KTS Technical Assistance Centre Service Information Bulletin

XEN Topaz Version 2.00 CPU Software

Operation Flow Chart

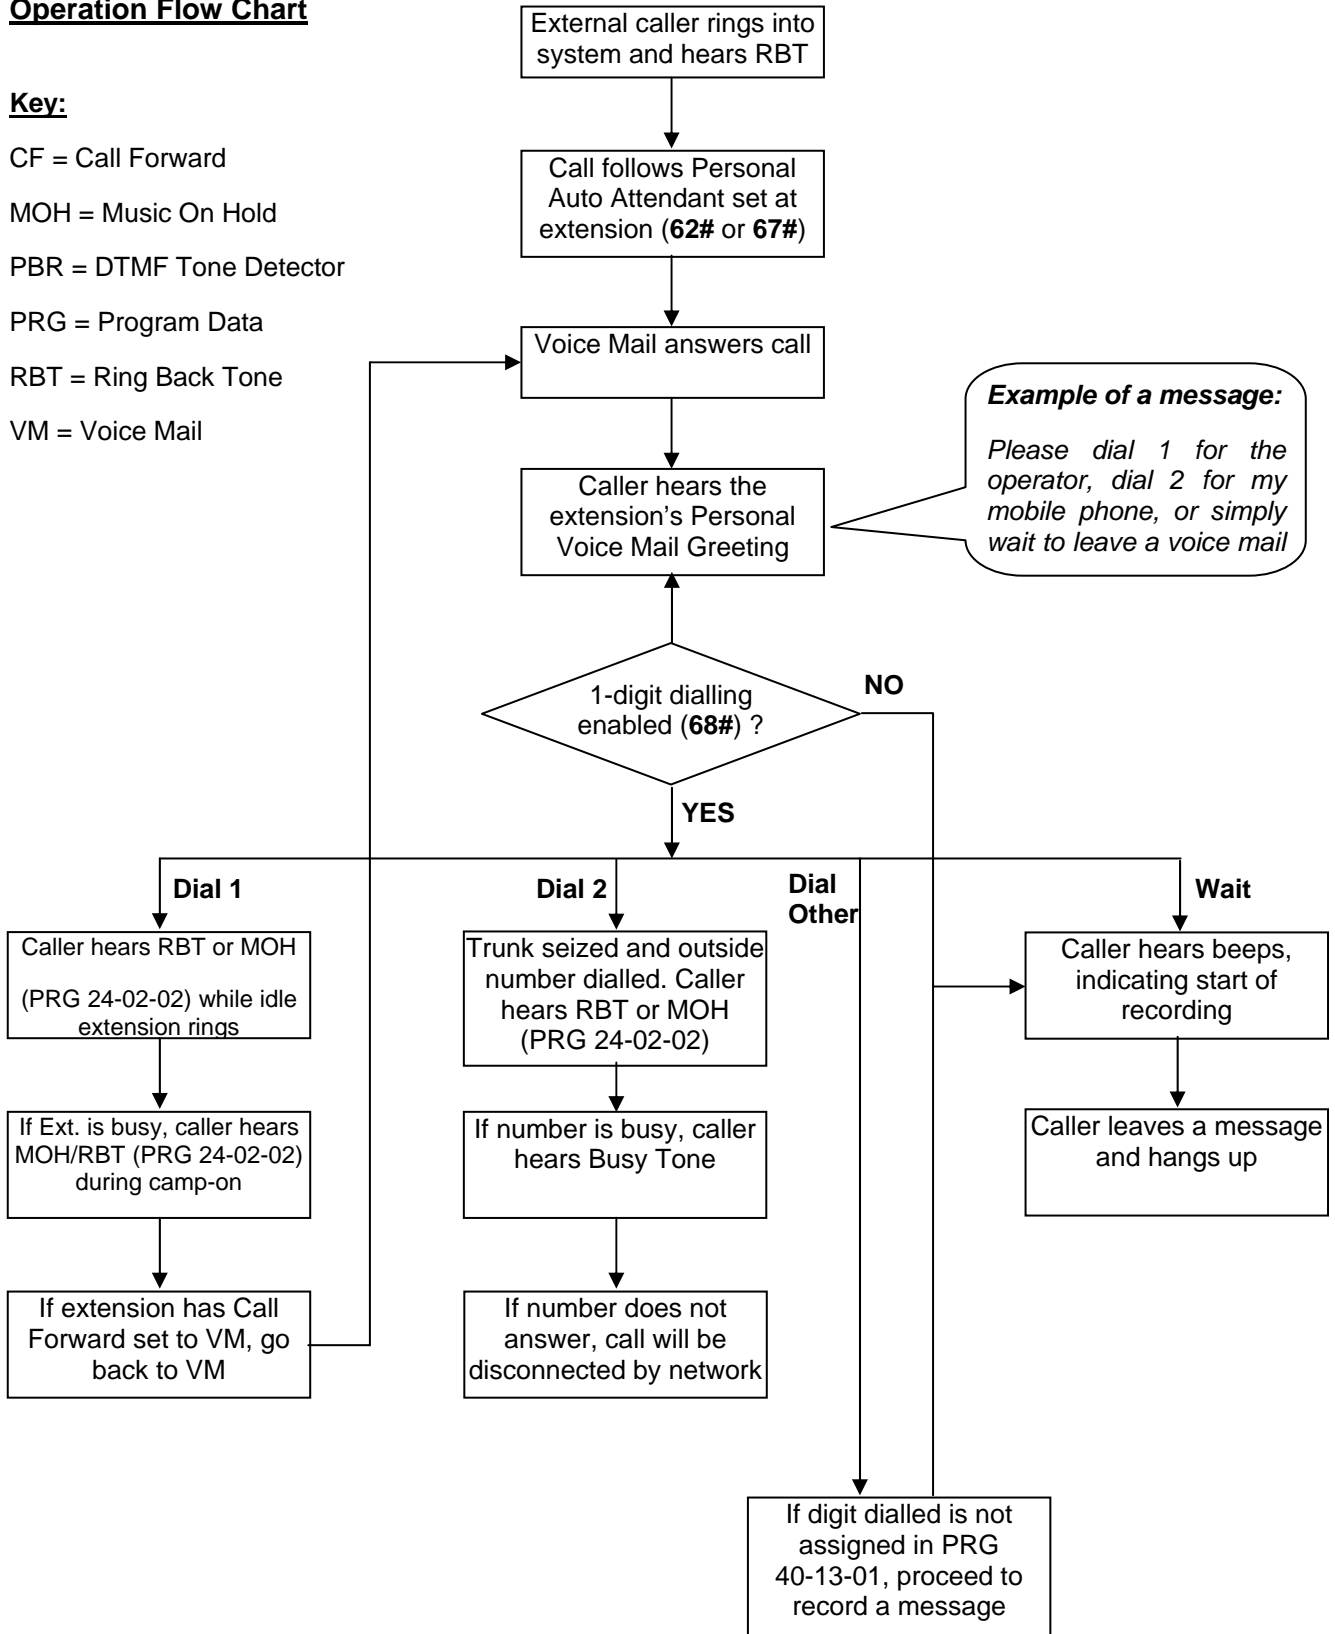
The Trunk-based Automated Attendant feature previously allowed a caller to dial a single digit or extension number to be transferred to an extension or VE, etc. Callers can now be transferred to an external number when they dial a single digit. The data assignment in PRG 25-06-02 now accepts a Common Abbreviated Dialling Bin number.

- MB 22-02-01 Incoming Call Trunk Setup – set to (VRS or Delay VRS/DISA)
- MB 25-02-01 DID/DISA VRS Message – set to VAU and additional data Message No (01~48)
- MB 25-06-02 **(Modified)** DID/DISA One – Digit Code Attendant Setup (Destination Number) – can be set to the following:
 - Extension Number, or
 - Department Group, or
 - Voice Mail Master Number, or
 - Common Abbreviated Dialling Bin Number.
- MB 25-06-03 **(NEW)** DID/DISA One – Digit Code Attendant Setup (Destination Type) – can be set to the following:
 - Internal Extension Number, or
 - Common Abbreviated Dialling Bin Number.
